ADDENDUM NO. 01

DATE 06.19.2014

PROJECT VMDO Project No.1115, Renovation of Three Residence Halls
PC# 217-17565-001

M301D

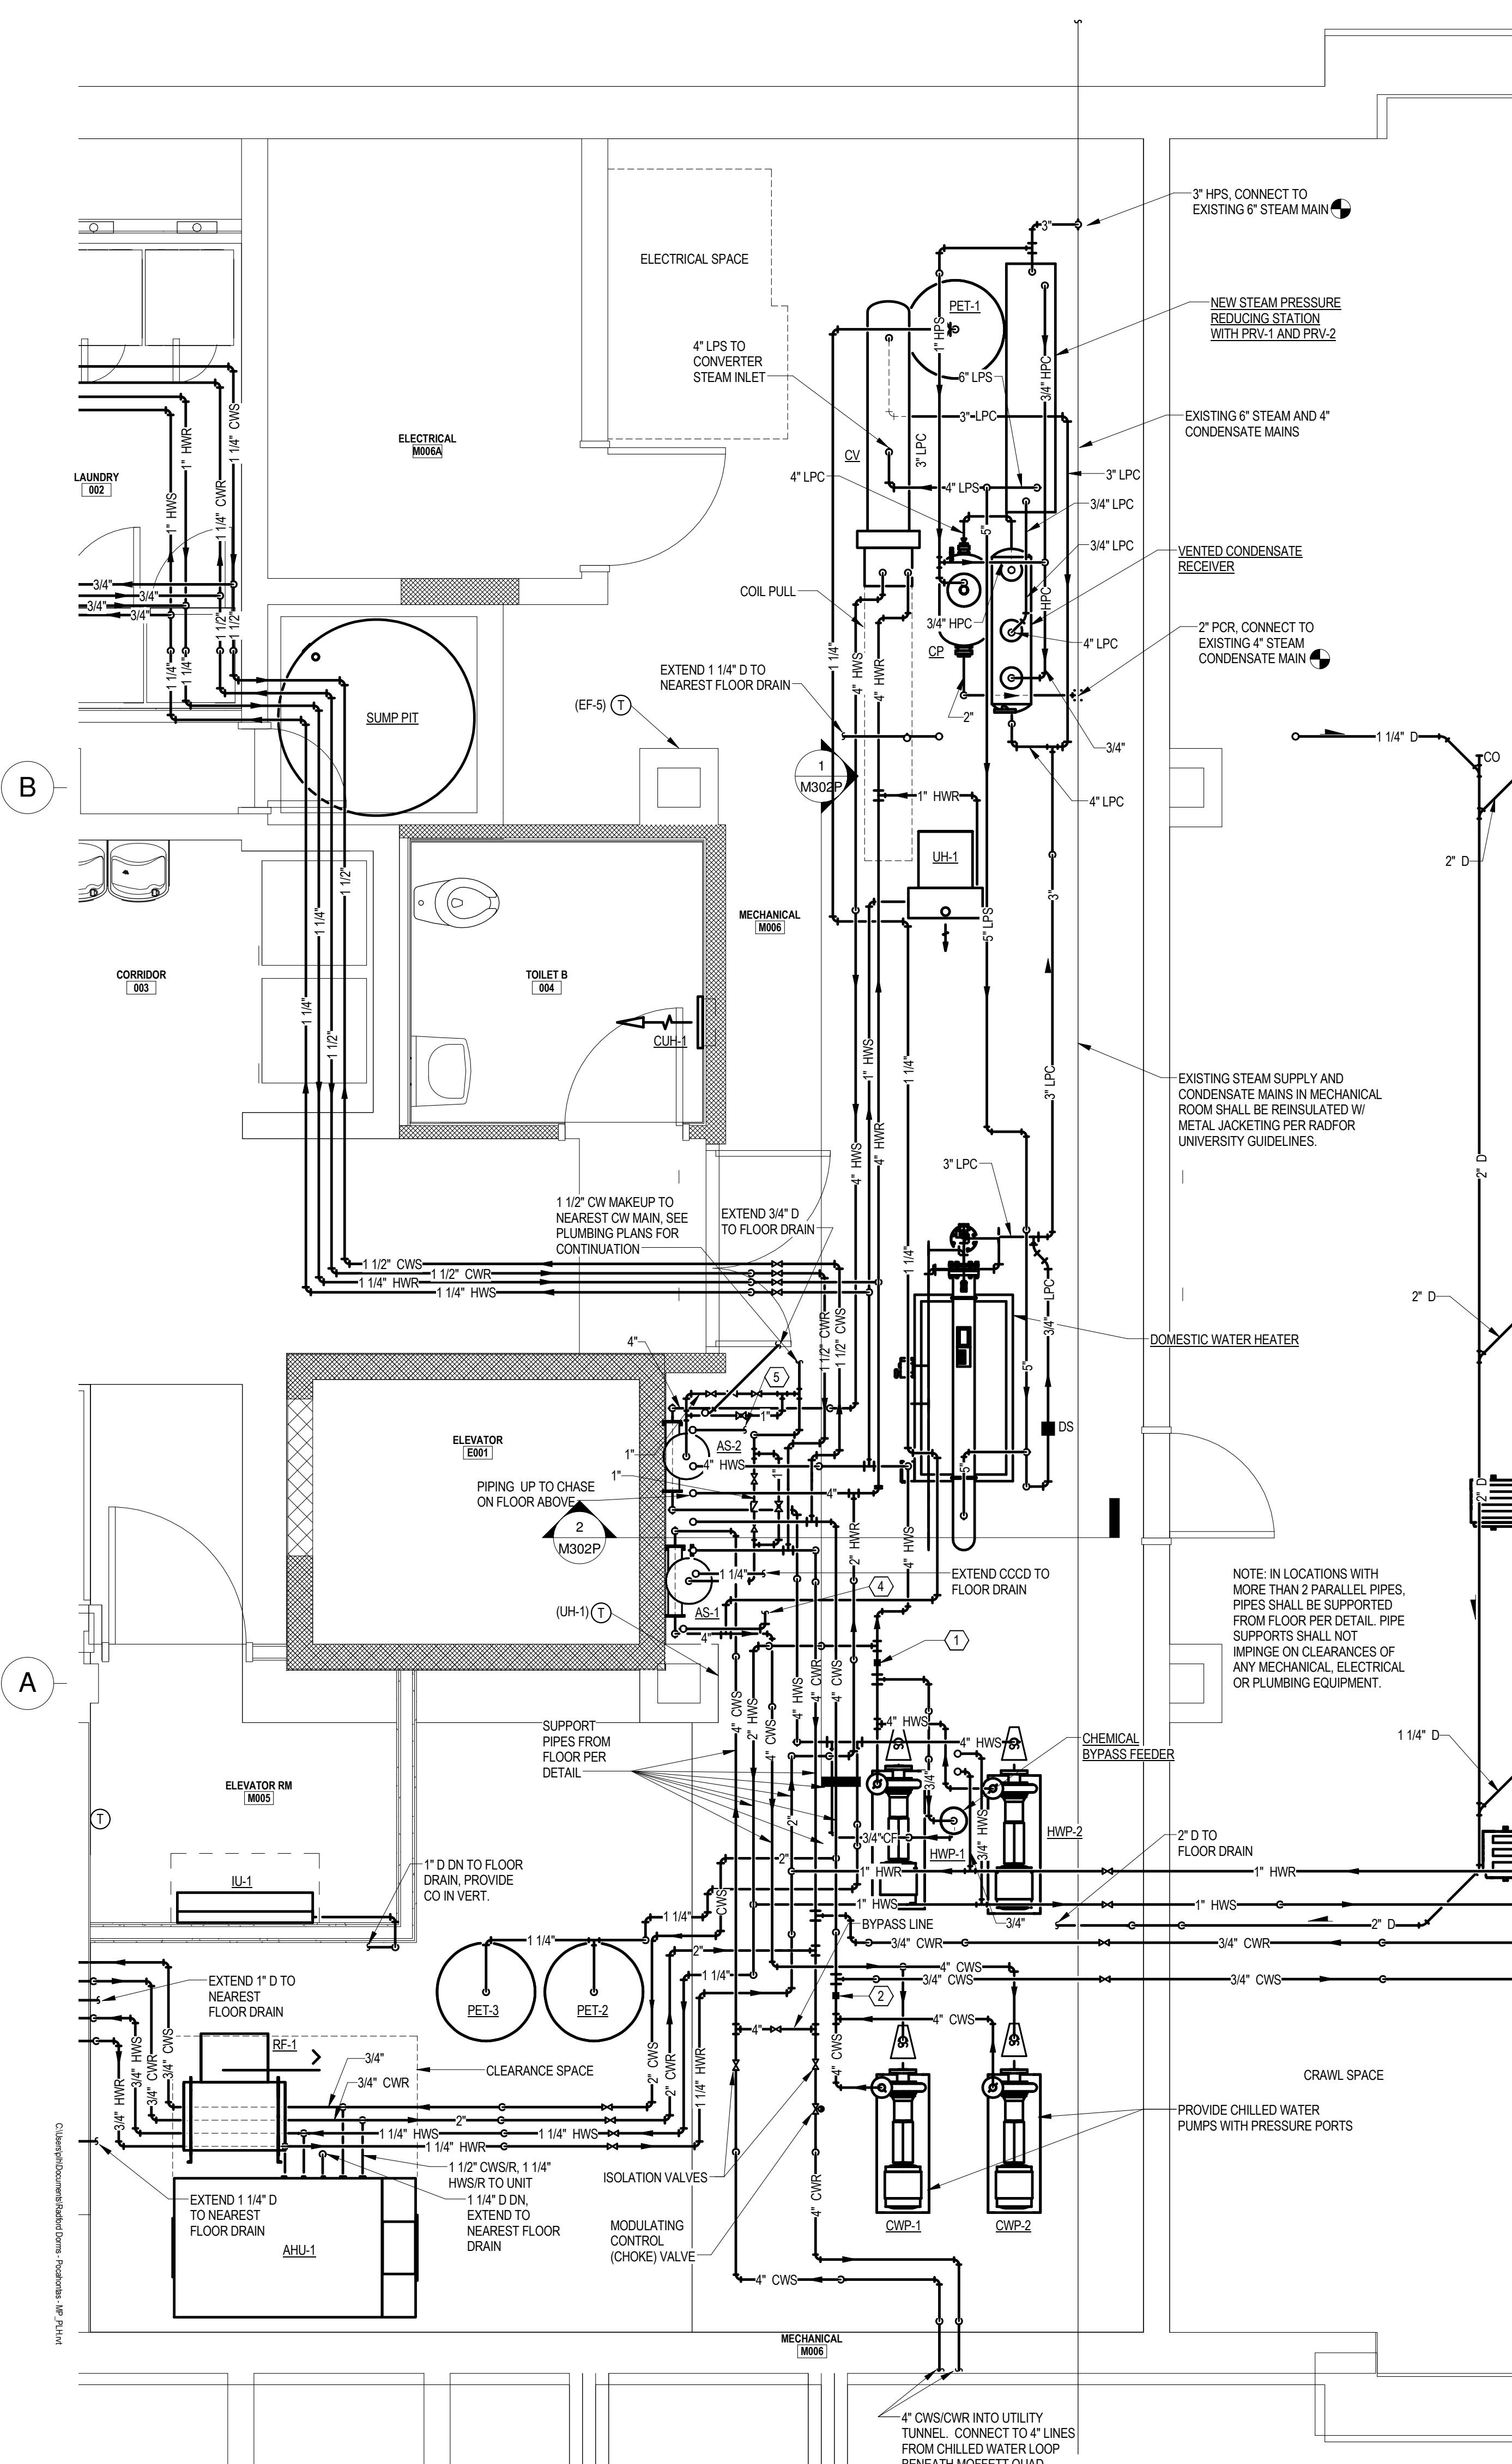
2.35 Remove fire dampers and added ductwork sizes to AHU-1 ductwork. Refer to attached revised drawing **M301D**.

2.36 Add airflow measuring station in AHU-1 outside air ductwork and modified plenum box size and duct routing. Refer to attached revised drawing **M301D**.

2.37 Add airflow measuring station in ERV-3 outside air ductwork. Refer to attached revised drawing **M301D**.

2.38 Note 3/8" graphic scale on revised drawing **M301D**.
